# **Brown Creek Tributaries Restoration Project FINAL Year 7 Monitoring Report/Closeout Report**

DMS Project ID No. 95351  
DEQ Contract No. 004641  
USACE Action ID: SAW-2012-01108  
DWR Project #14-0345  
RFP #16-004108 (Issued 6/20/2011)  
Yadkin River Basin: 03040104-061030

**Subject:** Response to DMS Comments for Task 13 Deliverables: Year 7 Monitoring Report  
Brown Creek Tributaries Restoration Project, Anson County, Yadkin River Basin – CU# 03040104,  
DEQ Contract No. 004641, USACE AID SAW-2012-01108, DMS Project #95351

Figure 2: Overview Map 1  
Current Conditions Plan View  
Monitoring Year 7  
Hurricane Creek Site

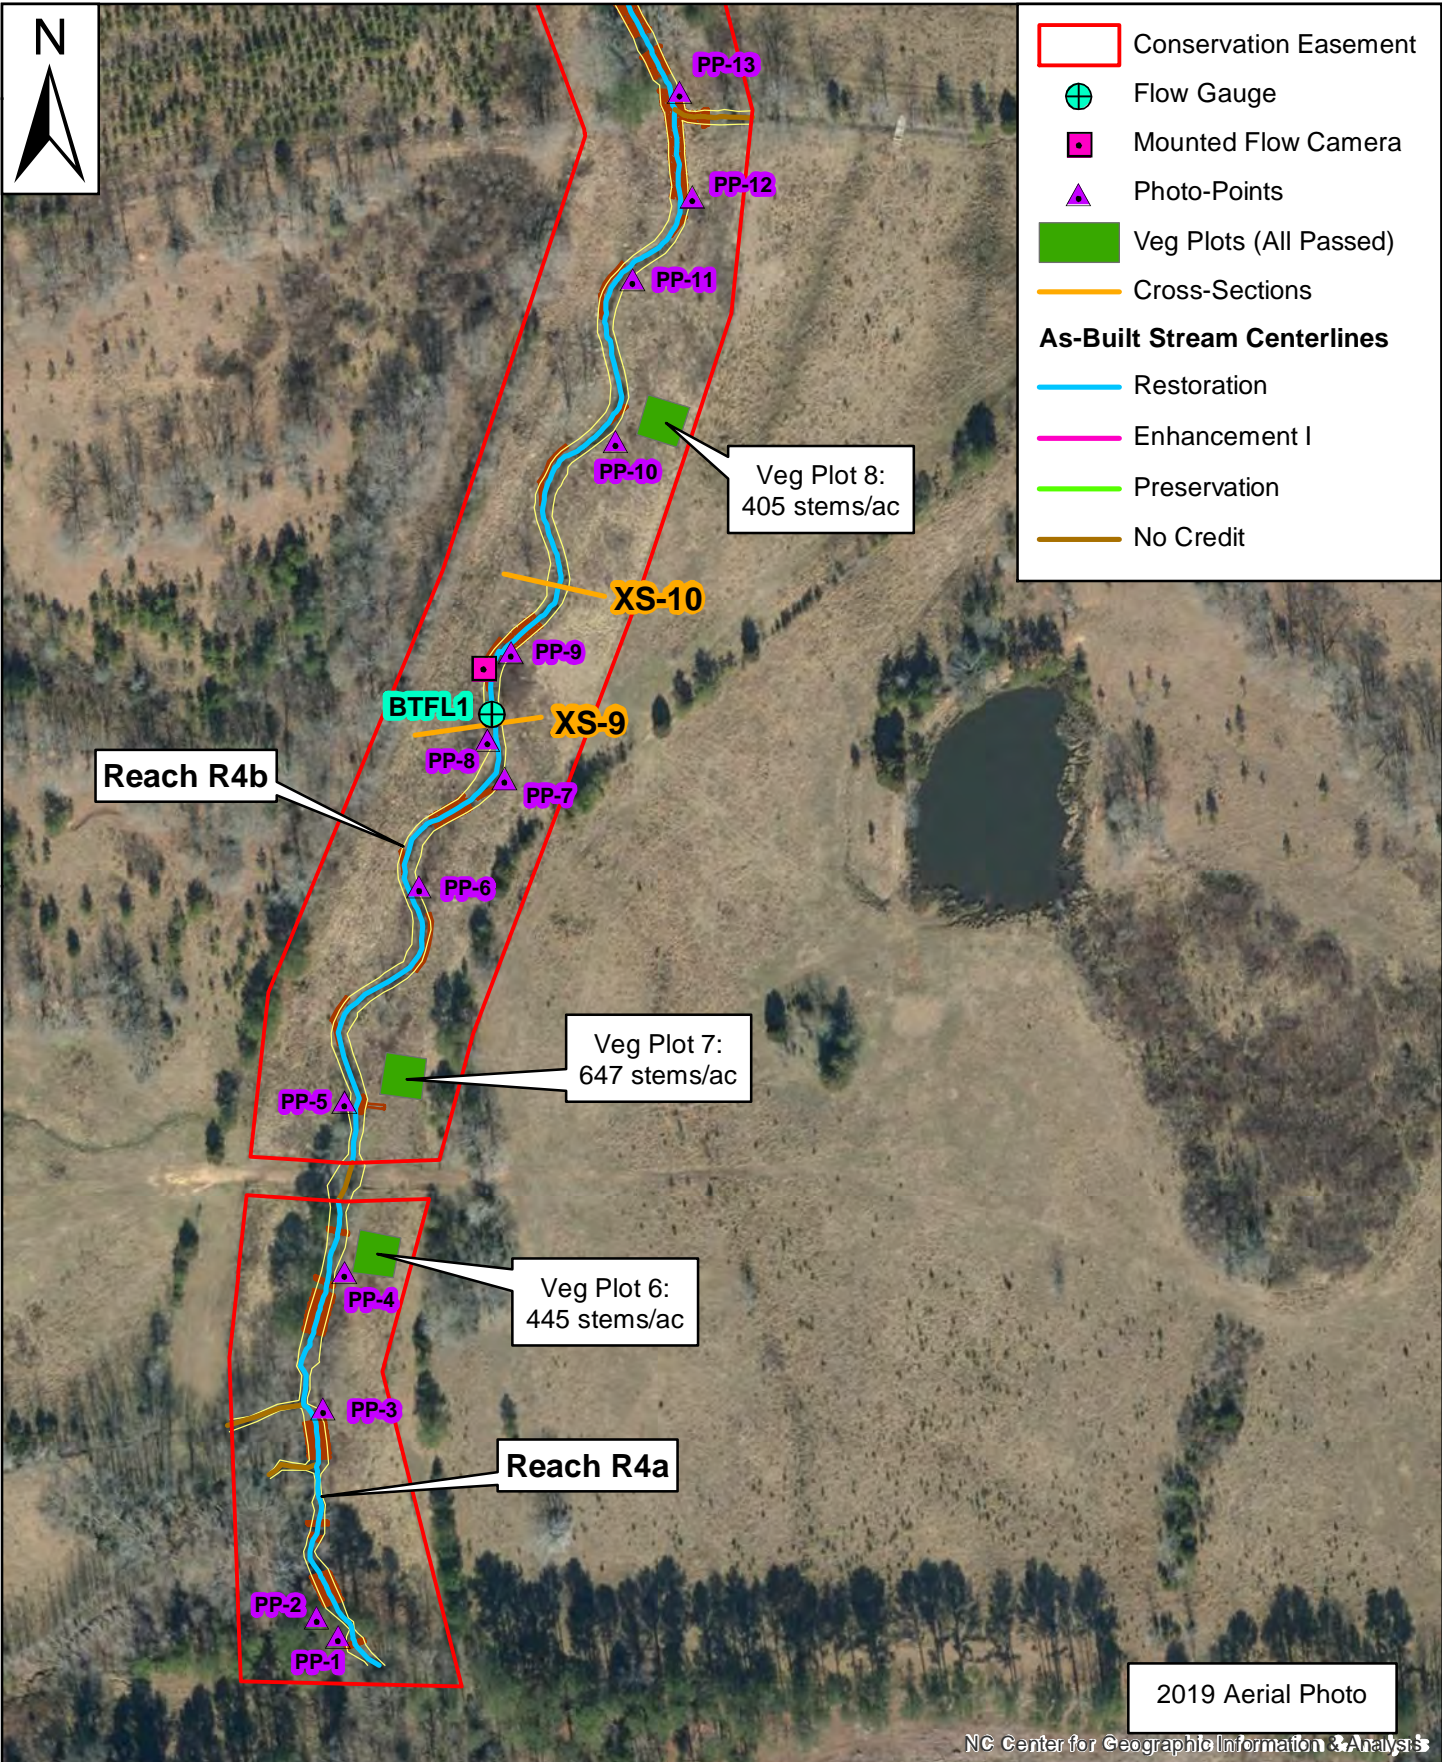
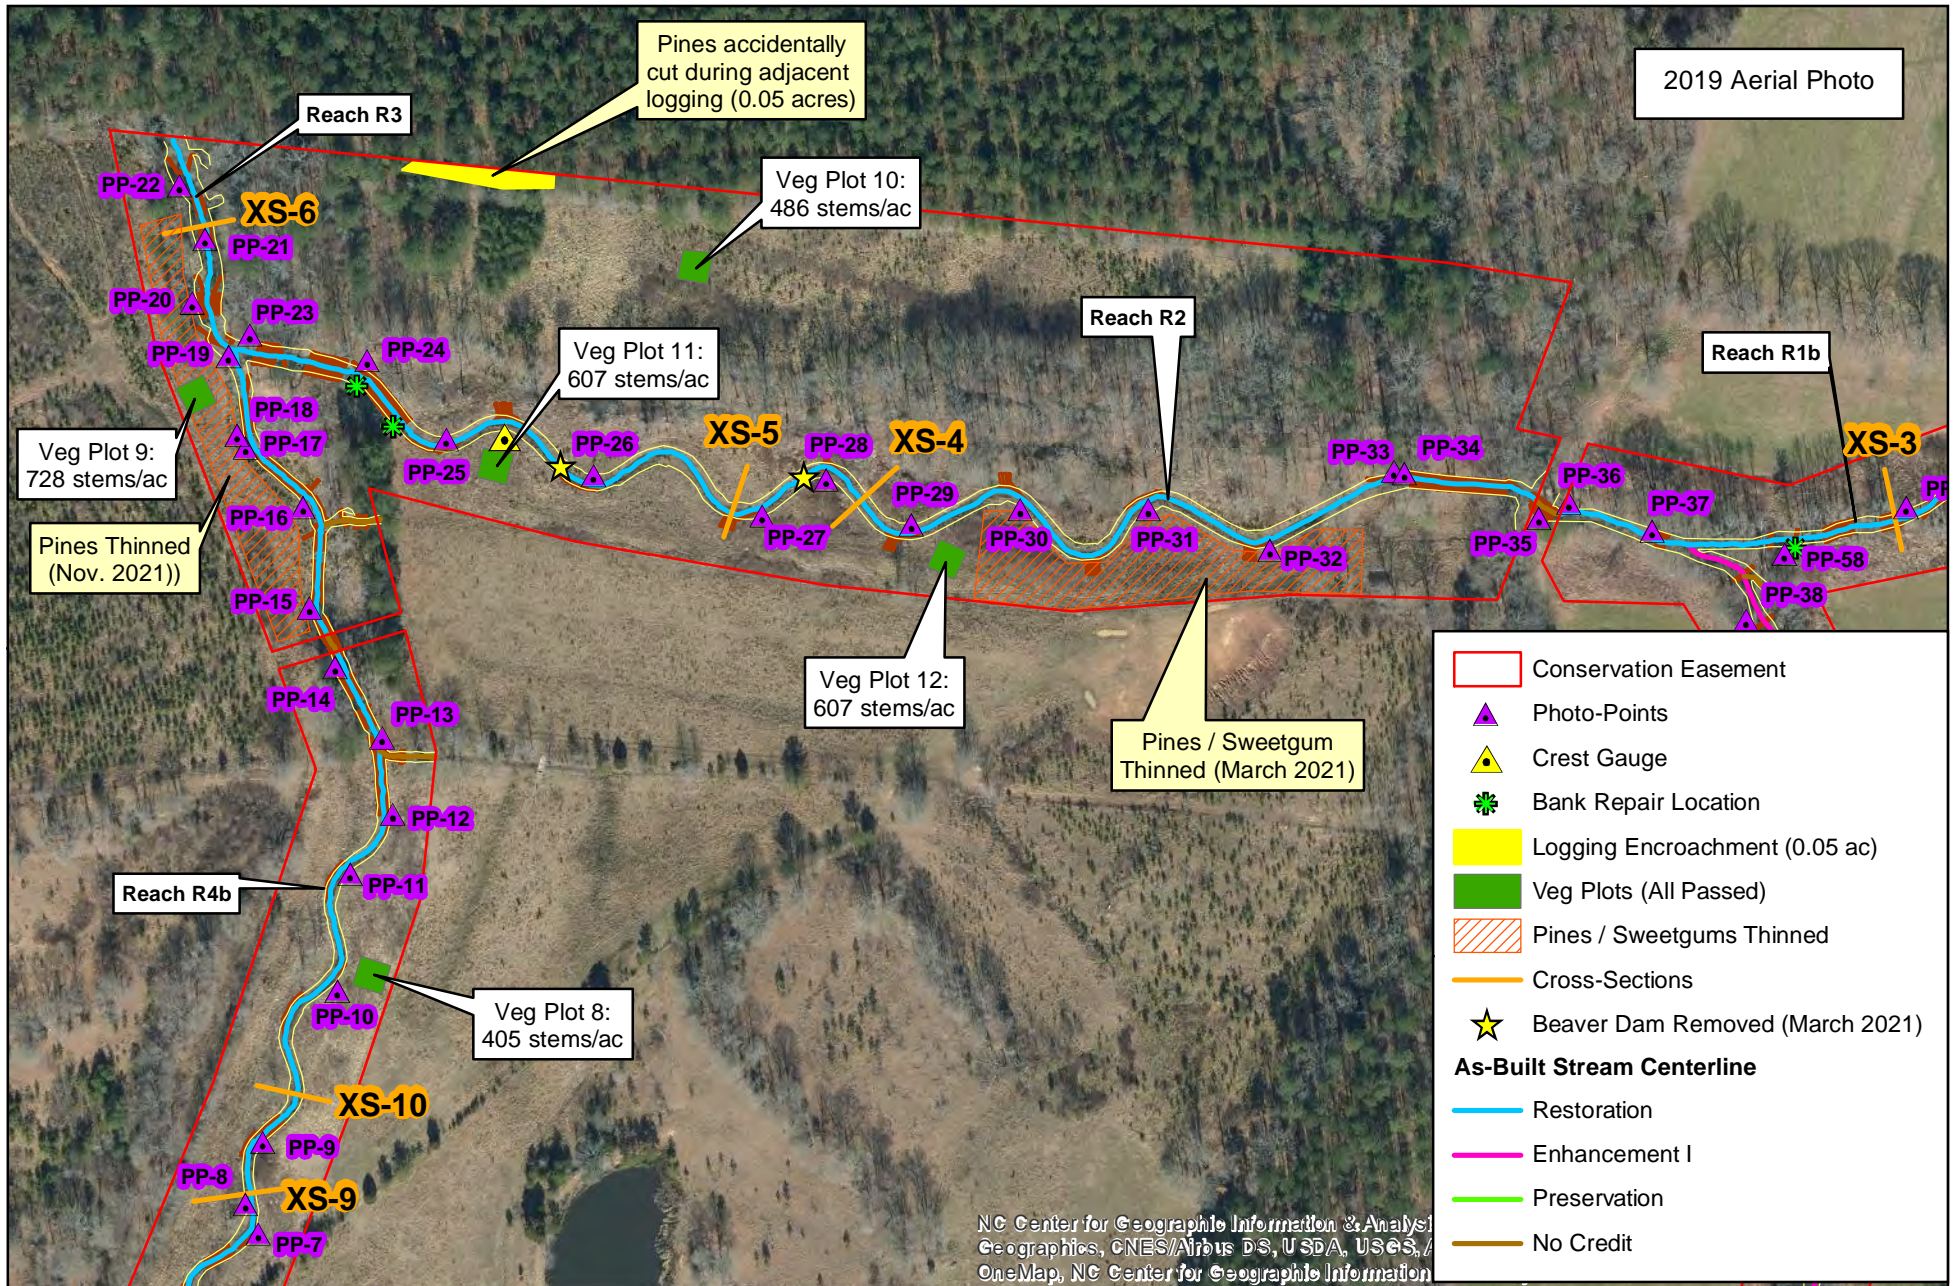
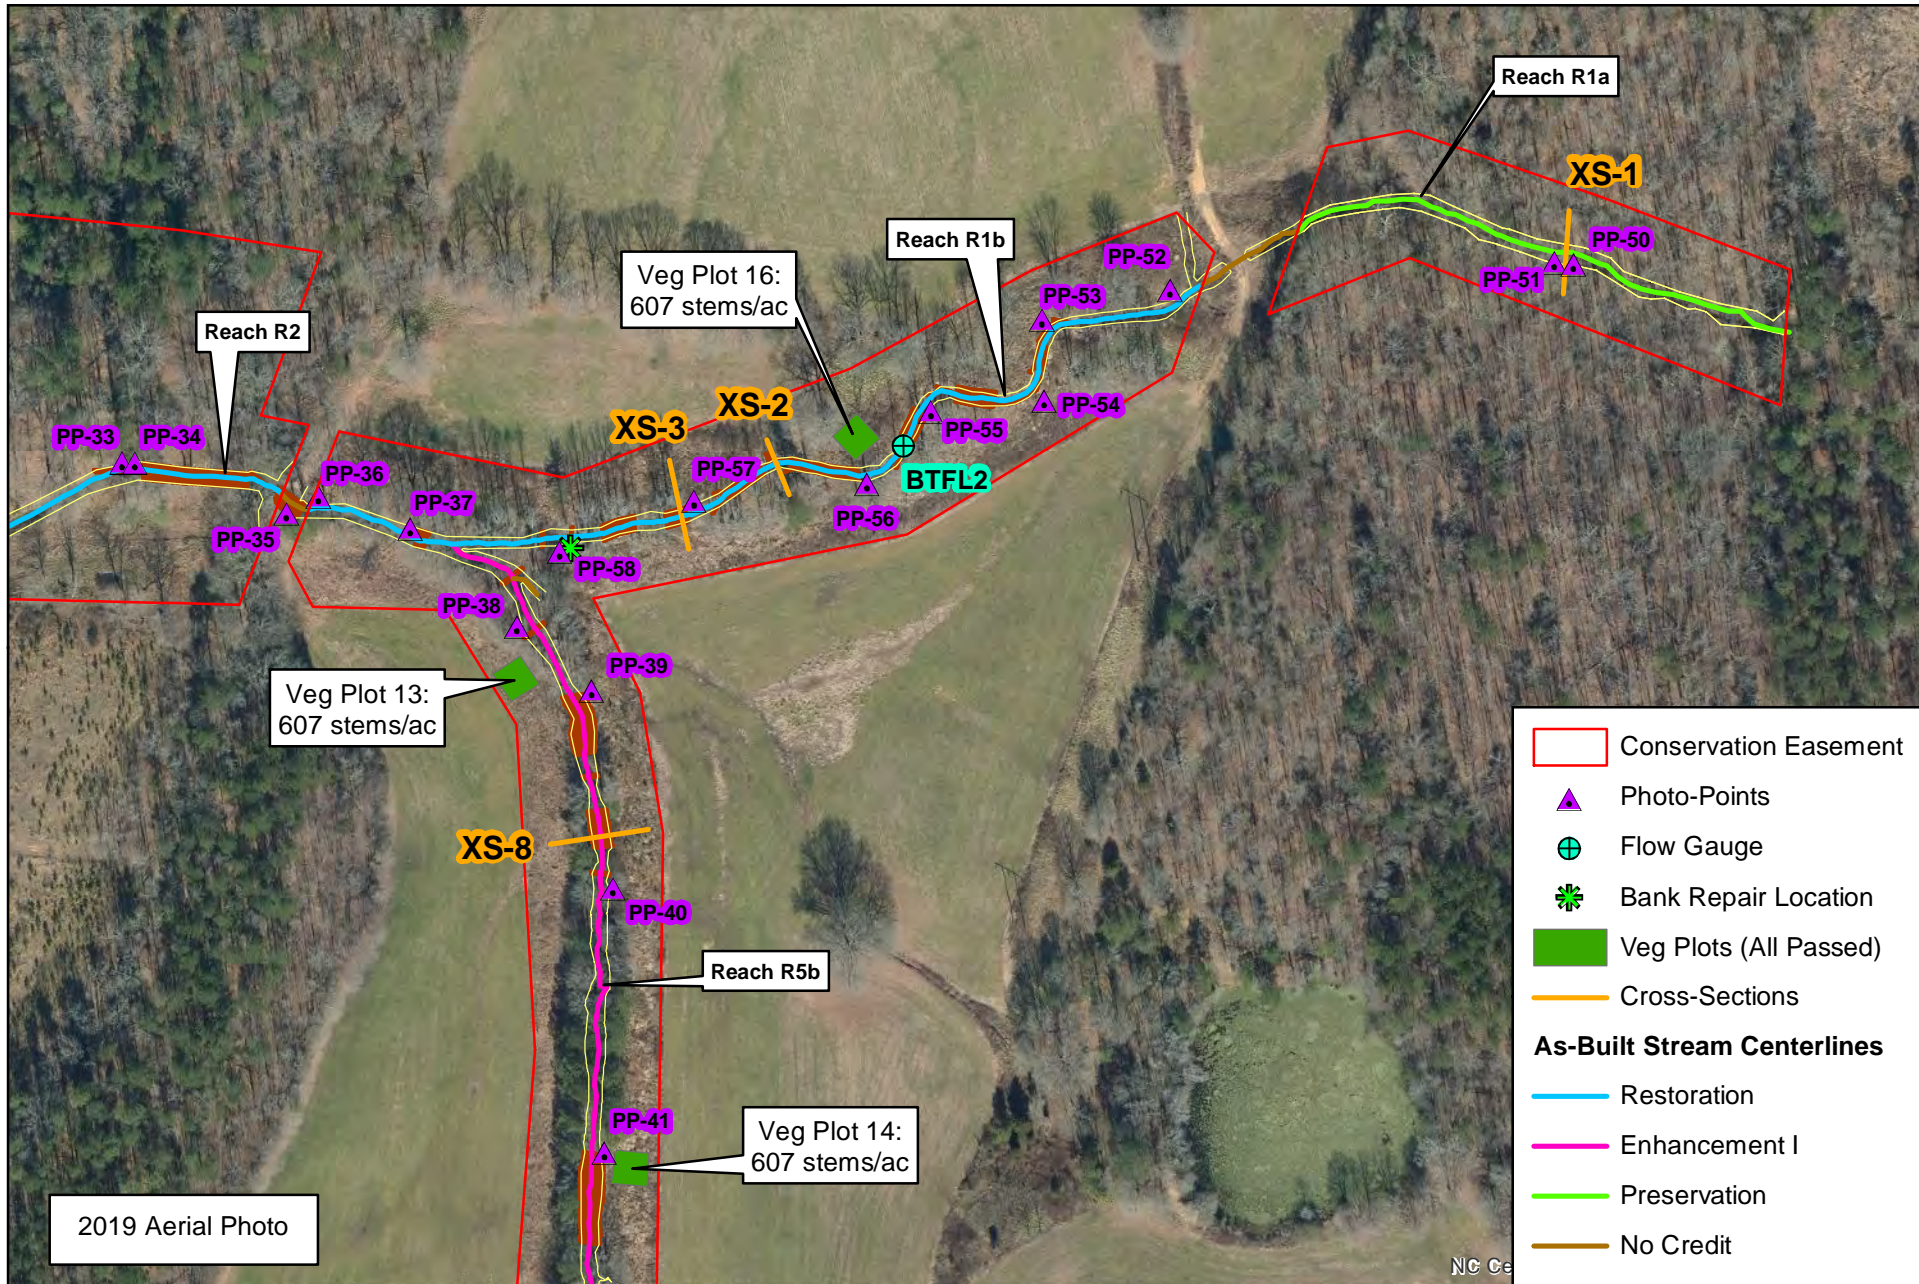
- Figure 2D: Thank you for adding the callout to show the area of pine harvesting within the easement.  
**Response: We appreciate the positive feedback.**
